City of Pembroke Pines Fire Rescue

FIRE SAFETY INSPECTION REPORT

Occupant Name:	Heron Pond Clubhouse	Inspection Date:	1/19/2023
Address:	8400 Southwest 1 Street	Inspected By:	Victor Santos
Suite:		Property Use Type:	Business office
Occupant Number:	10000222	InspectionType:	Annual Fire Alarm (FAS), Annual Fire and Life Safety Inspection, Annual Gate Inspection
Occ. Sq. Ft.:	4000	Number of AEDs:	0

1.13 -
10.1.4.1.

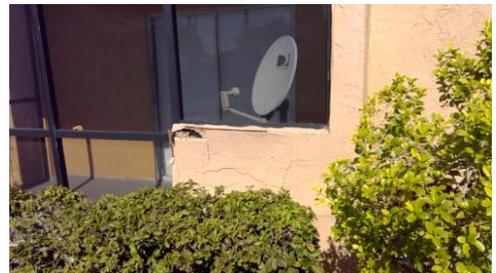
Deficiency	FL NFPA 01 2018 Chapter 10 General Safety Requirements	10.1.4.1 - Excerpt: Where structural elements have visible damage, the AHJ shall... (see photo 1.1, 1.2, 1.3, 1.4, 1.5, 1.6, 1.7, 1.8, 1.9, 1.10, 1.11, 1.12, 1.13, 1.14, 1.15, 1.16, 1.17)
-------------------	---	---

Inspector Comments: ***The noted structural damages have been referred to the City's Building Official and Structural Chief for evaluation of possible unsafe conditions. A site visit with structural inspectors and the Building Official to demonstrate areas of concern was conducted. Following the site visit, an structural engineer was consulted and in conjunction with the Building Official, deemed each patio/balcony area unsafe. The Building Official instructed Xochitl Alvarez, the property manager, to produce an analysis and proposal completed by a structural engineer for conditions and repairs within 48 hours. Each building and unit had an "Unsafe Building" notice posted on the front door as well as verbally communicated with residents who were home at the time. Residents were instructed that due to the unsafe conditions, they are to remain clear of the patio/balcony area until further notice is given.***

Where structural elements have visible damage, the AHJ shall be permitted to require a technical analysis prepared in accordance with Section 1.15 to determine if repairs are necessary to restore structural integrity.
